RECREATIONAL VEHICLE SAFETY RECALL NOTICE
Safety Recall: 23V-822
Safety Advisory: 23-447
October 16, 2026

IMPORTANT SAFETY RECALL – *7th Notice*

Figure 1

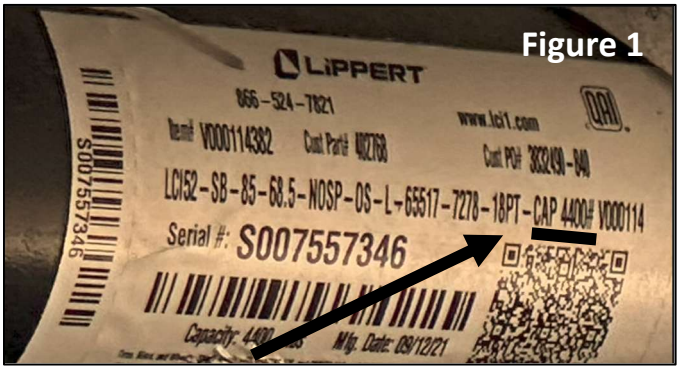
Reason for this recall It has been decided that the vehicles in the recall population may have axle springs rated at 4400 pounds rather than the 5100 pound axle rating as specified on Federal Identification Tag. The axles installed had the wrong size springs. Under certain conditions during travel, undersized axle springs can be overloaded leading to an increased risk of axle spring failure and increasing the risk of a crash.

You may choose to self-inspect the axle's tags. If the tag reads as CAP 4400#, as shown in Figure 1, as soon as possible, please make an appointment to have your RV serviced by your dealership. Customers should unload all cargo and empty holding tanks (fresh water, grey water, black water, and water heater) and take their unit to an authorized dealer for remedy of the incorrectly installed axles springs. The labor time to perform this correction is approximately 1 ½ hours. Please ask your dealer if you wish to know how much additional time will be needed to schedule and process your RV for this repair.

What we will do Keystone representatives have been in contact with the staff at your selling dealership regarding this situation. The remedy is to replace under rated 4400 LB springs with the correct size 5100 LB springs. This would require both 2200 LB springs be replaced. The service and parts required for this corrective action will be provided at no charge to you.
